Access Compliance Report Public Rights-of-Way (Curb Ramps)

Intersection ID: 10019463 Main Street: ALEXANDER_MARTIN_AV Cross Street: N/A Location: SW Ramp Type: PerpDiag **Overall Compliance: No** ADA ID: 0CAEBD8BF72C Initial Pass/Fail: Fail **Severity Score:** 12.5

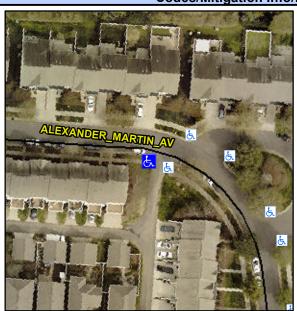
Possible Solutions:	
Remove & Replace Curb Ramp With Two New Directional Ramps or	
Equivalent.	I
Duminium Maton	
Surveyor Notes:	
N/A	
PROW/ADA:	
Not Found, R304.2.2

Field Measurements/Component Compliance							
Comp	liance Description	Data	Comp	liance Description	Data		
N/A	Ramp Length (in)	87.0	No	Ramp Slope (%)	10.1		
Yes	Ramp Width (in)	50.0	Yes	Ramp XSlope (%)	1.2		
N/A	Flare Type LT	N/A	N/A	Flare Type RT	N/A		
N/A	Flare Slope LT (%)	N/A	N/A	Flare Slope RT (%)	N/A		
N/A	Flare Traversable LT?	N/A	N/A	Flare Traversable RT?	N/A		
N/A	Landing Length (in)	N/A	N/A	DWS Provided?	N/A		
N/A	Landing Width (in)	N/A	N/A	DWS Contrast?	N/A		
N/A	Landing Slope (%)	N/A	N/A	DWS Length (in)	N/A		
N/A	Landing X Slope (%)	N/A	N/A	DWS Full Width?	N/A		
N/A	Landing Curb? (Y/N)	N/A	N/A	DWS Offset (in)	N/A		
N/A	Shared Landing?	N/A					
N/A	Gutter Ponding?	N/A	N/A	Gutter Slope (%)	N/A		
N/A	Gutter Lip Ht (in)	N/A	N/A	Gutter X Slope (%)	N/A		
N/A	Painted X Walk1?	No	N/A	Painted X Walk2?	No		
	X Walk 1 Direction	To SE		X Walk 2 Direction	To N		
N/A	X Walk 1 Width (in)	N/A	N/A	X Walk 2 Width (in)	N/A
